**BEST STREAM AND WETLAND RESTORATION PROJECT
MONITORING REPORT
MONITORING YEAR 4
FINAL**

DUPLIN COUNTY, NORTH CAROLINA
CONTRACT No. 004631 - PROJECT No. 95353
USACE Action ID No. 2012-01384 -NCDWR Project No. 13-0865

RE: Best Stream and Wetland Restoration Site: MY4 Monitoring Report (NCDMS ID 95353)

Listed below are comments provided by DMS on December 14, 2018 regarding the Best Stream and Wetland Restoration Site: Year 4 Monitoring Report and RES' responses.

Figure 3b

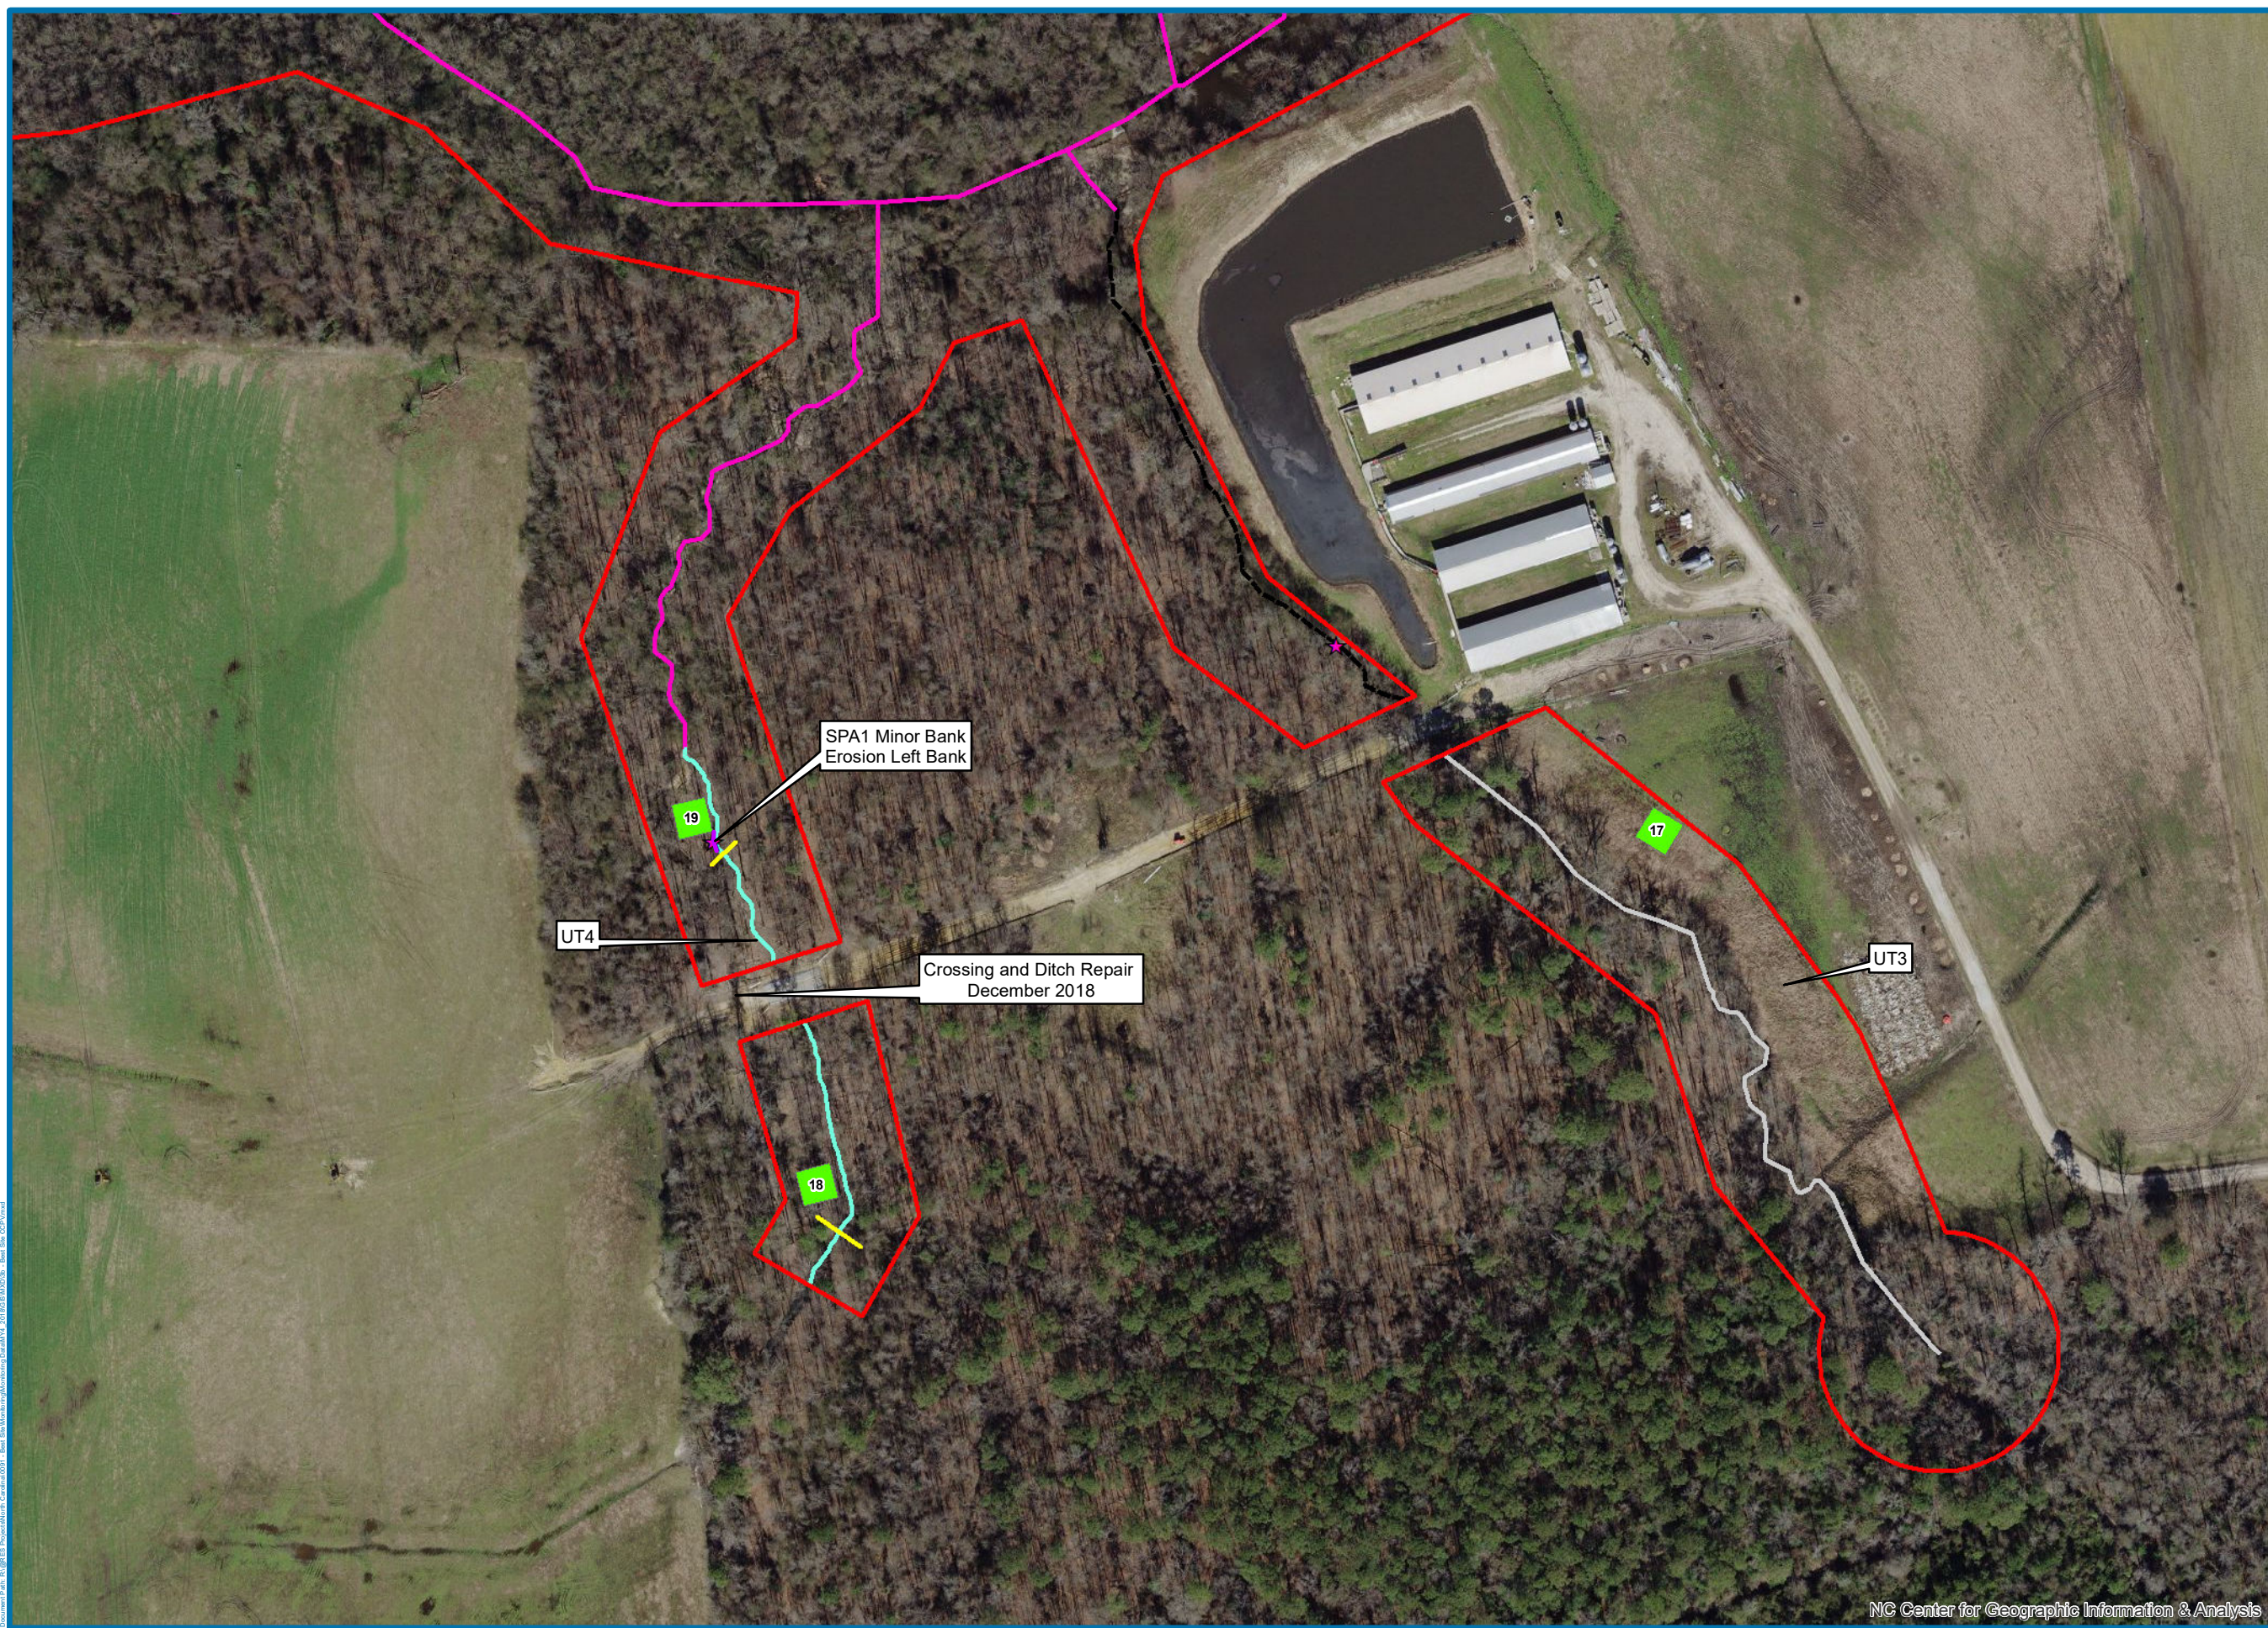
Table 5, UT4 shows an area of scour/erosion. Please provide GIS shapefile.

[Done.](#)
